TRANSMITTAL OF MEETING HANDOUT MATERIALS FOR IMMEDIATE PLACEMENT IN THE PUBLIC DOMAIN

Catawba Nuclear Station, Units 1 and 2

To discuss the results of control room
in-leakage testing at Catawba, and to discuss
partial implementation of alternate source
term application at Catawba

**CATAWBA NUCLEAR STATION
FHA AND WEIR GATE DROP ACCIDENT
REG GUIDE 1.183 APPENDIX B ANALYSIS
PRESENTATION TO NRC
FEBRUARY 21, 2002**

SCALE 1" = 100'
DUKE POWER
CATAWBA NUCLEAR STATION
PLOT PLAN FOR
CONTROL ROOM HABITABILITY
ASSESSMENT
FIGURE: 1

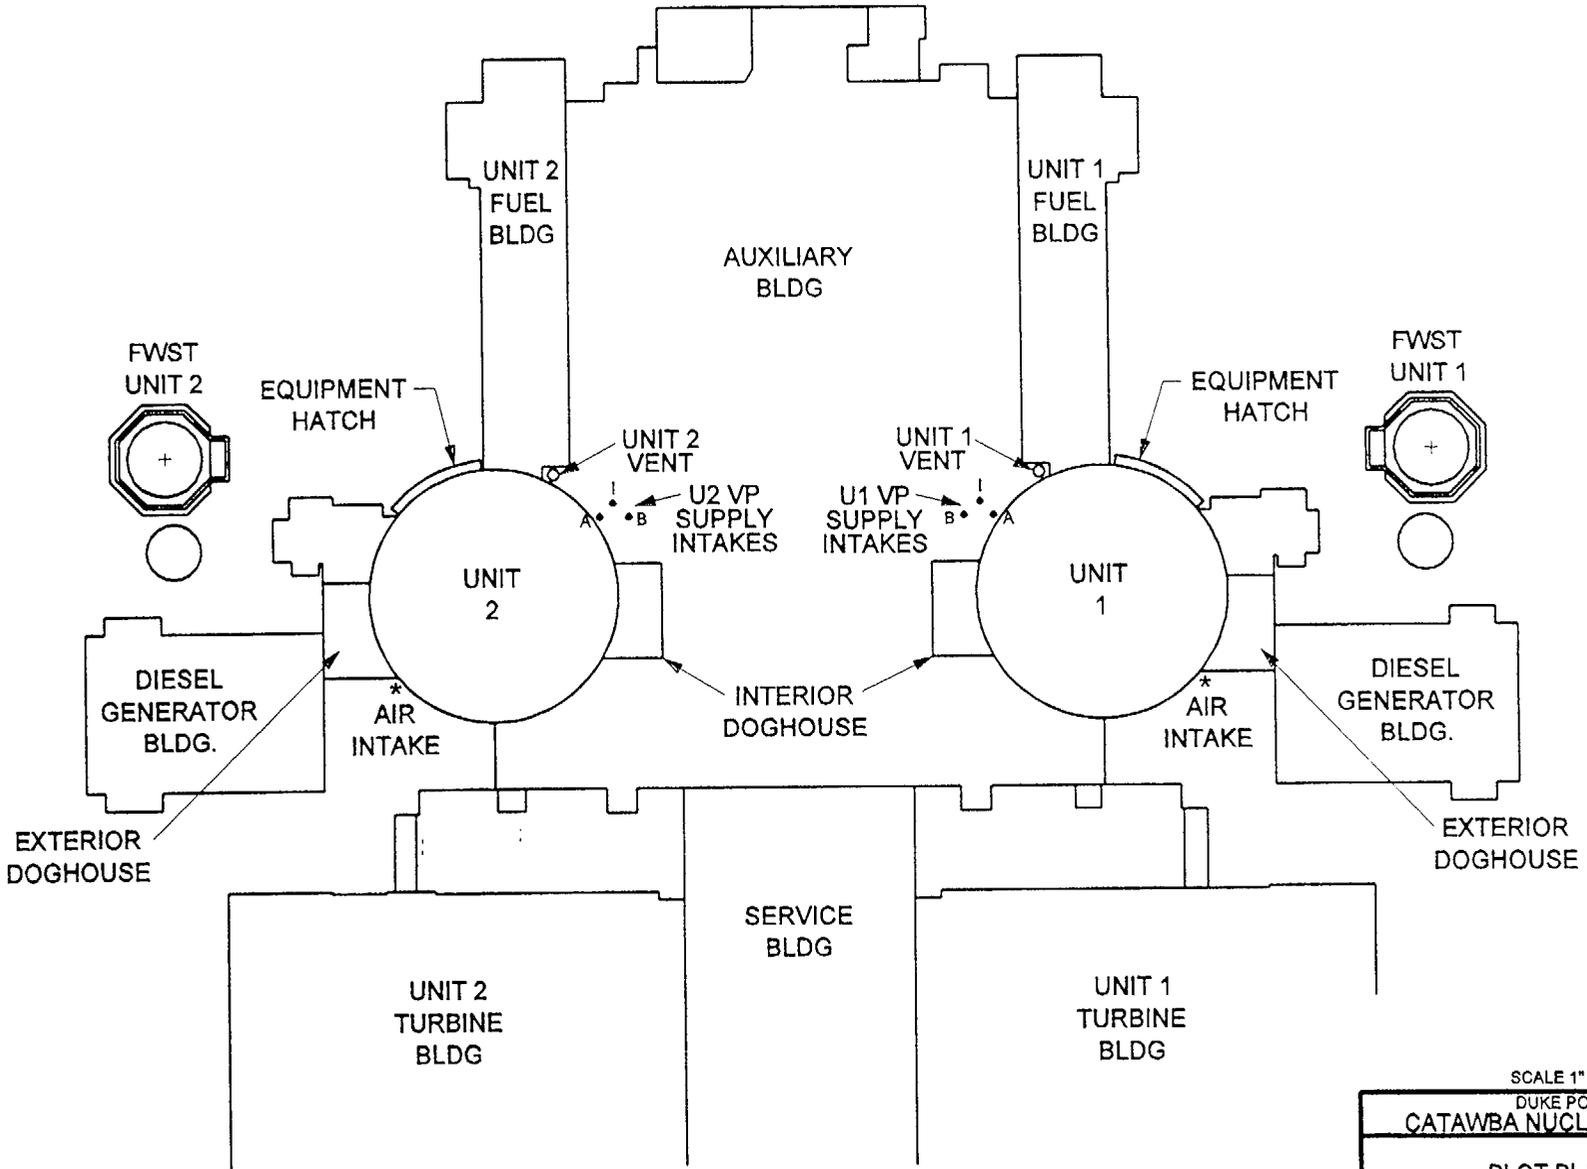
2) Show that you have the limiting control room X/Q for the design basis (DB) fuel handling accident (FHA) and weir gate drop (WGD). This control room X/Q is associated with releases from the unit vent stack for all of the above design basis accidents. Discuss the effects of loss of offsite power and single failure in your control room X/Q.

How has the Reactor Building, being a distance of only 2 meters from the outside air intakes, been considered as a potential release source for the FHA in containment?

- Values of zero are assumed for the vertical velocity and stack radius parameters, in order to treat the release as a ground-level release in ARCON96.
- **Figure 1 from the calculation is being provided in hardcopy, showing the plot plan of Catawba Nuclear Station.**

In this calculation, all distances are the straight-line horizontal distances from source to receptor, except for releases from the equipment hatch to receptor intakes on the same unit, in which case the flow must go around the containment building to reach the closest air intake. For the flows around containment, wind directions are also different from the straight down-wind directions.

All distances and directions are rounded to whole numbers. For horizontal and vertical area sources, the distance to the closest edge of the source is input as the horizontal distance. Note that the distance to the equipment hatch deviates from this practice, as the distance is measured from the equipment hatch centerline. ARCON96 uses the horizontal distance to calculate an effective distance to the area source, which it treats as a virtual point source farther upwind.

All wind directions are measured from True North. The difference between station north and True North is noted on **Figure 1** as 1 degree 11 minutes and 5 seconds west of station north at CNS.
